## PORTFOLIO HOLDER DECISION NOTICE

### **TOPIC – TRAFFIC REGULATION ORDER – ST THOMAS STREET AND SYMONDS STREET, WINCHESTER**

Title: PROPOSED REVISION TO  
WAITING RESTRICTIONS  
ST THOMAS STREET & SYMONDS STREET  
WINCHESTER

DRG. No. 810402/229/001 A

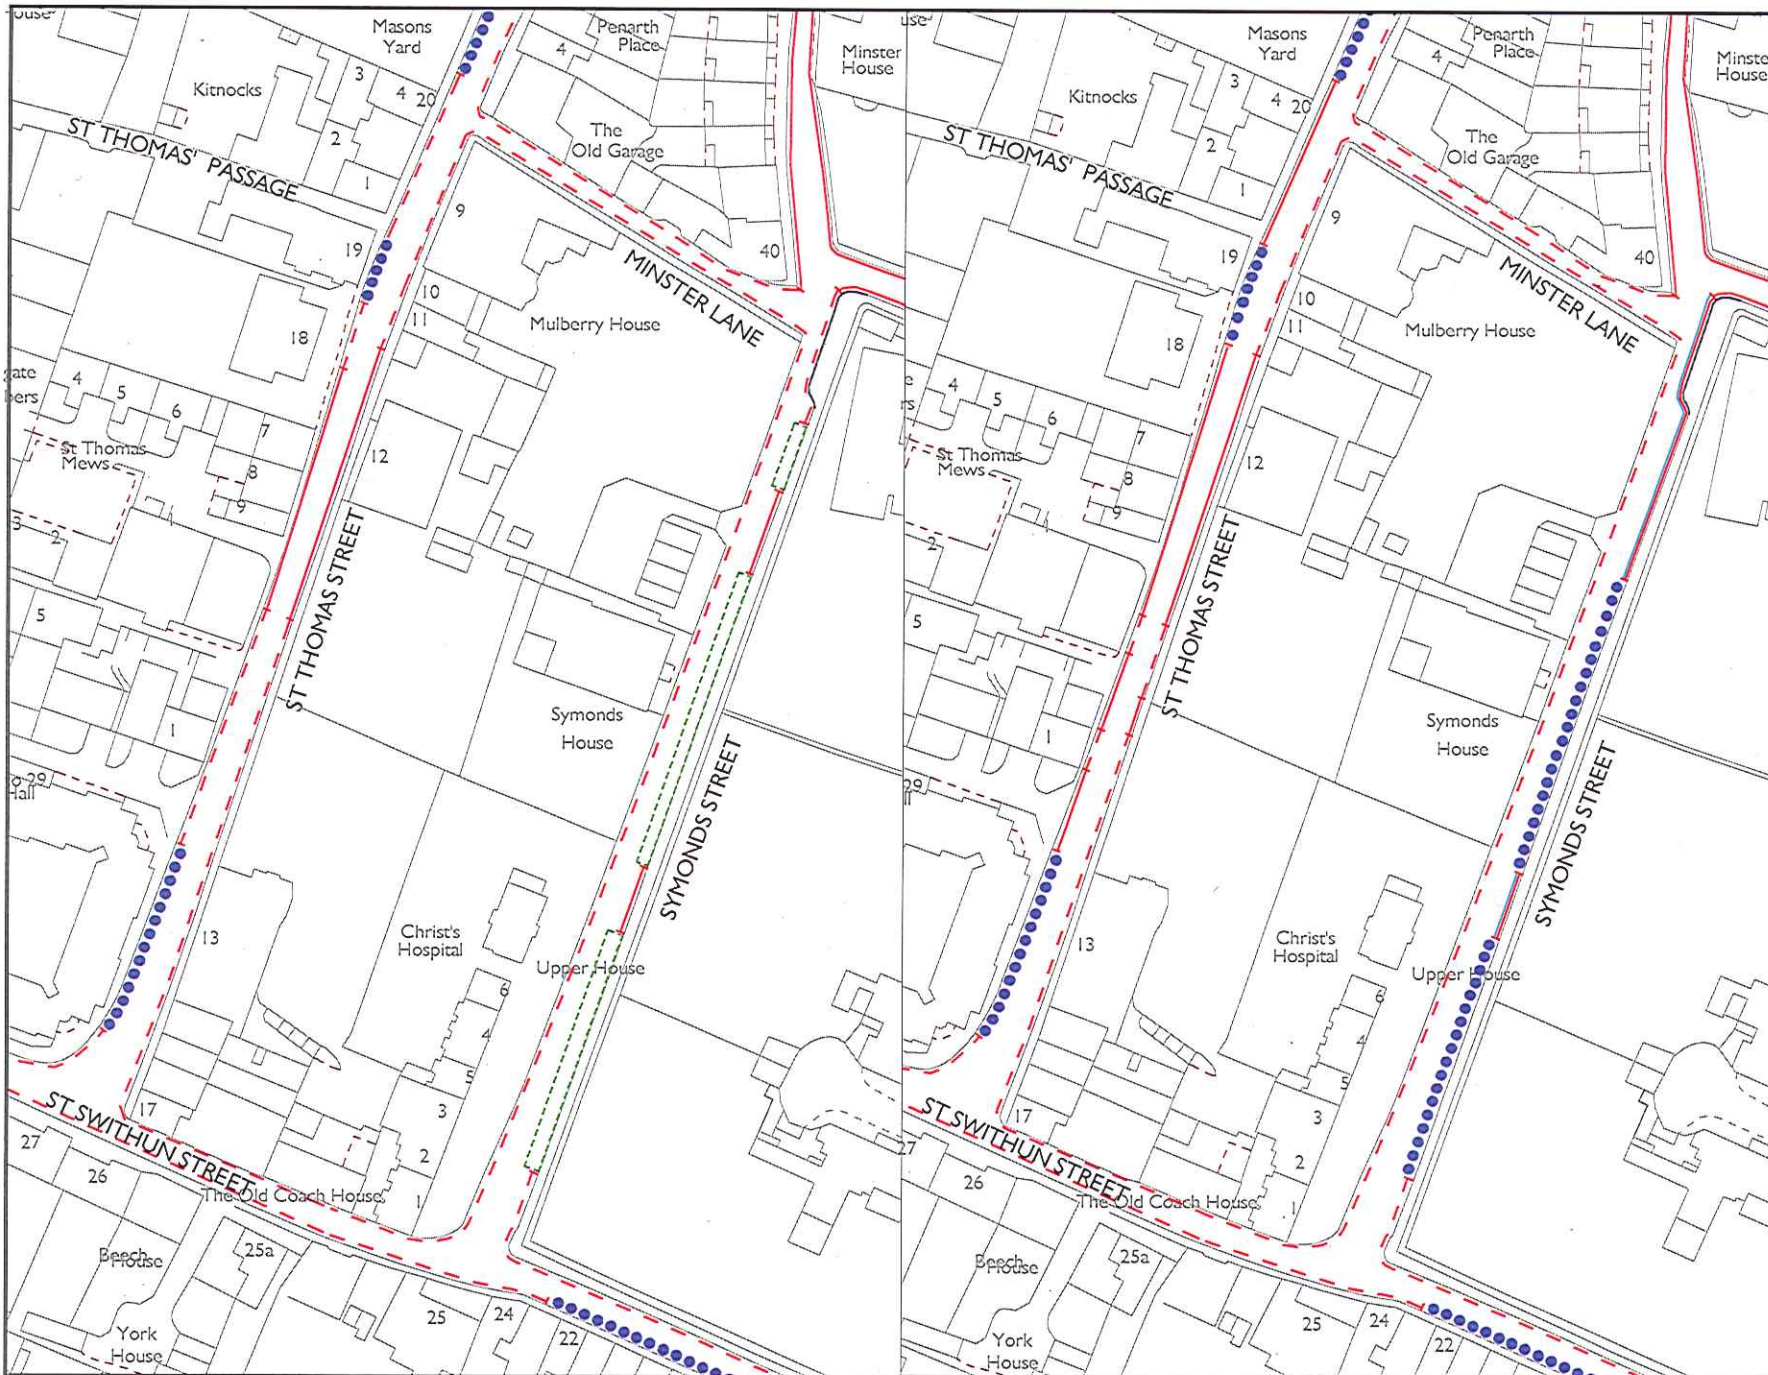
Regarding the double yellow lines which you propose to place between No 1 and 4 Masons Yard, please would you reconsider ? We use this space for offloading our shopping, and as a 75 years old woman, I would find it difficult to carry bags any great distance. It is also very handy for me to park after 6.p.m. if I go out. Often at that time most spaces near my home are full. The extension from 2 to 3 bays outside 18 and 19 St.Thomas Street will also be of great help, thank you.

With regard to the proposed Traffic Regulation Order in regard to parking on Symond's Street, Winchester, we note that the two parking spaces nearest to the cathedral (junction with Minster Lane) would be replaced with No Waiting/No Loading.

As we cannot understand how this contributes to the objective to "maximise on street parking provision", we wish to object to the proposal on these grounds.

1. The removal of the ability to park outside Mason's Yard between the hours of 6pm and 8am. These spaces are really valuable to us after work when all the permit bays are full. They also allow us to park outside our properties in the evening and on Sunday so that we can wash our cars and load/unload shopping and other heavy items. We were wondering if this restriction will encourage vehicles to park on the single yellow opposite Mason's Yard and adjacent to Mulberry House which may cause more of an obstruction to the flow of traffic. This area may well need an additional review as it can be tight for vehicles turning left from Minster Lane but, in practice, the whole strip across Mason's Yard does not need to be restricted in the manner proposed to allow ease of passage for vehicles, in our opinion.
